# Access Compliance Report

## Public Rights-of-Way

Intersection ID: 30230	Main Street: MONTBROOK_DR	Cross Street: MORNINGSIDE_RD	Location:	N
ADA ID: EE5E5CB0E5D7	Ramp Type: Perp	Initial Pass/Fail: Fail	Overall Compliance: No	Severity Score: 1.25
Codes/Mitigation Info/Possible Solution		Field Measurements/Component Compliance

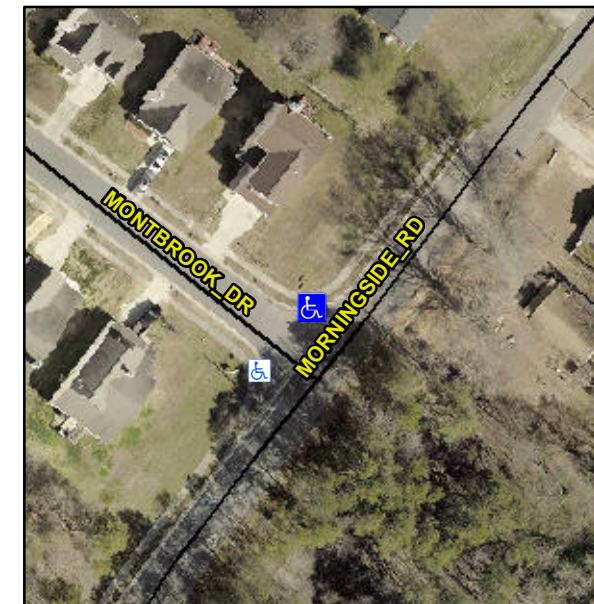
**Not Found, R304.5.3**

Compliance	Description	Data	Compliance	Description	Data
N/A	Ramp Length (in)	46.5	Yes	Ramp Slope (%)	8.1
Yes	Ramp Width (in)	49.0	No	Ramp XSlope (%)	4.0
N/A	Flare Type LT	N/A	N/A	Flare Type RT	N/A
N/A	Flare Slope LT (%)	N/A	N/A	Flare Slope RT (%)	N/A
N/A	Flare Traversable LT?	N/A	N/A	Flare Traversable RT?	N/A
N/A	Landing Length (in)	N/A	N/A	DWS Provided?	N/A
N/A	Landing Width (in)	N/A	N/A	DWS Contrast?	N/A
N/A	Landing Slope (%)	N/A	N/A	DWS Length (in)	N/A
N/A	Landing X Slope (%)	N/A	N/A	DWS Full Width?	N/A
N/A	Landing Curb? (Y/N)	N/A	N/A	DWS Offset (in)	N/A
N/A	Shared Landing?	N/A			
N/A	Gutter Ponding?	N/A	N/A	Gutter Slope (%)	N/A
N/A	Gutter Lip Ht (in)	0.5	N/A	Gutter X Slope (%)	N/A
N/A	Painted X Walk1?	No	N/A	Painted X Walk2?	N/A
	X Walk 1 Direction	To SW		X Walk 2 Direction	N/A
N/A	X Walk 1 Width (in)	N/A	N/A	X Walk 2 Width (in)	N/A
	X Walk 1 Slope (%)	3.8		X Walk 2 Slope (%)	N/A
	X Walk 1 X Slope (%)	2.1		X Walk 2 X Slope (%)	N/A

**Remove & Replace Entire Ramp.**
